**SITE PLAN REVIEW COMMITTEE
MEETING AGENDA**

DATE: Thursday, October 26, 2017
TIME: 7:00 – 9:00 p.m.
PLACE: 2011 Crystal Drive, 11th Floor
Arlington, VA 22202

Item 1. Crystal Square North Retail (SP #90) 7:00 – 9:00 p.m.
(RPC # 34-020-248 through -251, 34-020-037, and 34-026-033)
Planning Commission and County Board meetings TBD.
Peter Schulz (CPHD Staff)

SPRC Agenda: First Meeting—October 26, 2017

**EXISTING AND PROPOSED BUILDING
CONSTRUCTION TYPES KEY PLAN**

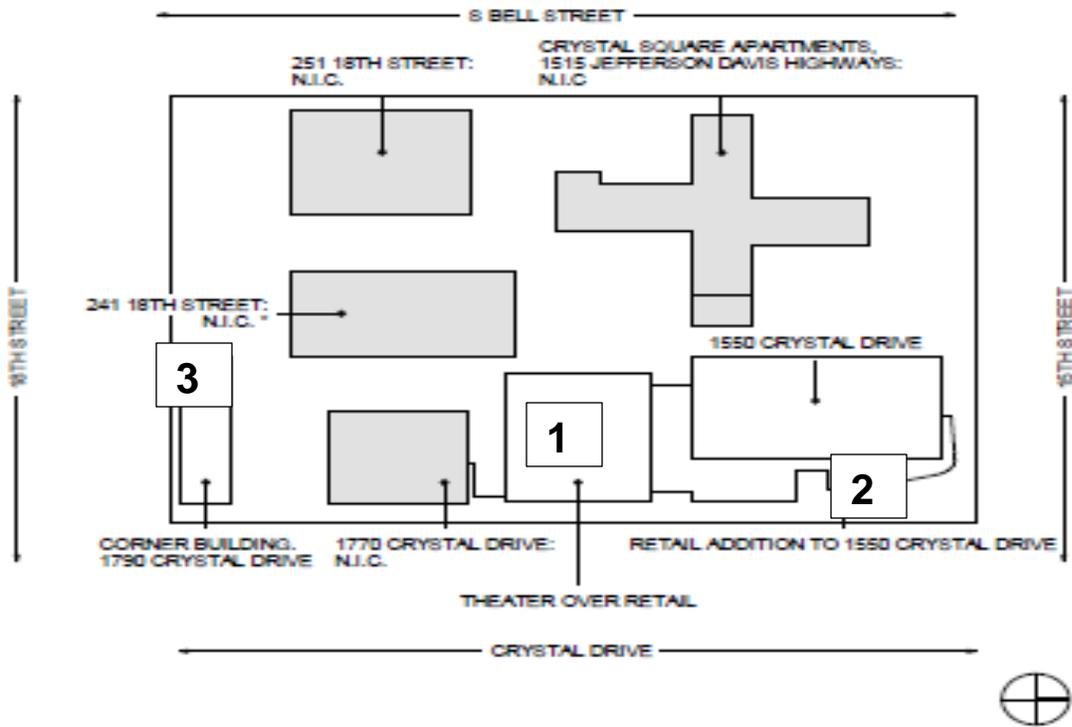
Above the first level of the movie theater, glass is replaced with a decorative metal screen at the mezzanine level (additional detail of which will be needed), and gray panels on the second level. A translucent feature stretching upward two (two) stories breaks the plainness of the upper stories.

The third level of the theater is set back from the lower levels, presents a plain gray wall to Crystal Drive. The developer’s plans state “potential art” and additional information will be needed on the visibility of this wall from public rights-of-way.

Agenda Item 3: Two-story corner retail building (Building #3)—The applicant proposes to place this building in what is planned to be an important public park, one of the most important open spaces envisioned in the Sector Plan. While the Sector Plan contemplates structures such as market sheds or a market-style “head house” (using examples such as Quincy Market in Boston), the Sector Plan did not envision an enclosed, private retail space at this location. Construction of such a building will limit the County’s options in using the space in the way envisioned in the Sector Plan. In addition, the developer’s proposed solution to the grade change in the site would result in really two (2) plazas, with a significant change in elevation that would discourage the traversal by commuters as envisioned in the Plan. It is more likely pedestrians will use the public sidewalks than use stairs.
